TOLEDO-LUCAS COUNTY PLAN COMMISSIONS

REF: SUP-1007-19

SUBJECT: Special Use Permit for a Community Recreation, Active Use at Christ the King Church

SOUTH ELEVATION
SCALE: 1/4" = 1'-0"

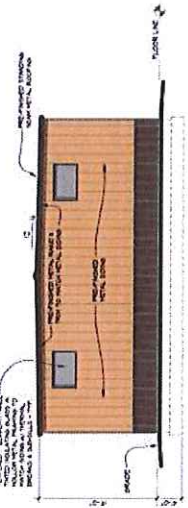
New structures are subject to TMC 1109.0200 Commercial, Mixed Use, and Institutional Design Standards. The standards require pedestrian connectivity and well-designed architecture achieved through variations in massing, character and image, and building façade treatments and materials. These standards are based on site specific context and overall visibility from public view. Given the location of these structures, design standards would primarily apply to the Sylvania facing facades. Pedestrian connectivity to the public right-of-way would be provided from an existing walkway. The fellowship hall meets the design requirements but the maintenance shed does not. Facades visible from the public right-of-way must comprise at least seventy-five (75%) of total wall area. The maintenance shed will be almost entirely metal paneling. However, given the location and size of the structure and the incorporation of a proposed landscape buffer between the shed and Sylvania Avenue staff would be supportive of a waiver from this requirement.

42. High quality building materials must comprise at least 75% of the total wall area for the south elevation of the maintenance shed. Metal paneling is not an acceptable material and shall be revised. **Applicant must obtain a waiver of TMC 1109.0205.B. or comply fully with the requirements of said section.**

Approve a waiver to allow metal panel siding for the maintenance building along the southern facade visible from the right-of-way.
